**CDL Response 09/02/2026 to Panel's Working Draft Conditions
For Comment released 23/01/2026**

ARATAKI PROJECT CONDITIONS OF CONSENT

ARATAKI ROAD CORNER LOTS CONSENT NOTICE (APPLIES TO LOTS 4, 11, 14, 27, 30, 48, 54, 60, 90 AND 98)

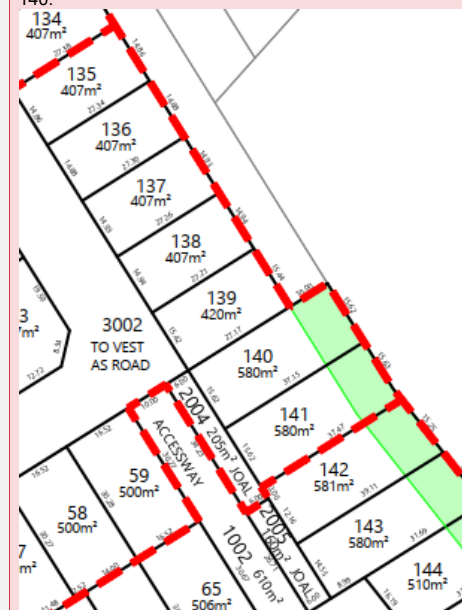
Commented [CDL47]: Requested amendment: As per above comments, this list should include Lot 140 which has a boundary with the Reserve land. This was an oversight in the original drafting of this condition. Please see scheme plan snippet below to show location of Lot 140:

Commented [CDL48]: Requested amendments: Lot 30 has accidentally been included in the list of applicable corner lots. Lot 30 will have direct access to Arataki Road and is adjacent to a JOAL - it is not a corner lot. Lot 48 should have been included as this is a corner lot to an Access Road. See plan snippet below.

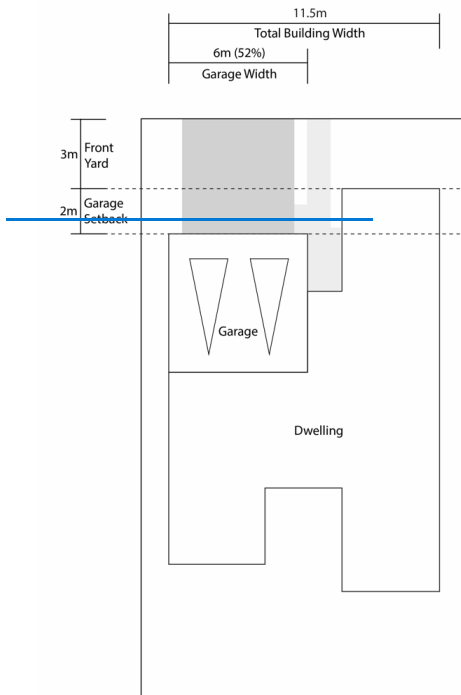
Commented [CDL53]: Accept amendments

~~The consent holder must register with the Registrar-General of Land a consent notice under Section 221 of the RMA, against the computer registers (certificates of title) for Lots 1-18, 21, 27-33, 38-44, 48-70, 73, 77, 82-102, 107-108 and 120, 122-150, 153-161, and 163- 171. The consent notice must record that the following condition is to be complied with on a continuing basis:~~

68H. Glazing & Street Connection (Lot Type 2)

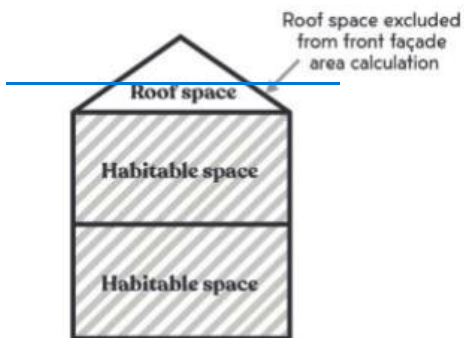
Commented [CDL59]: Accept amendments
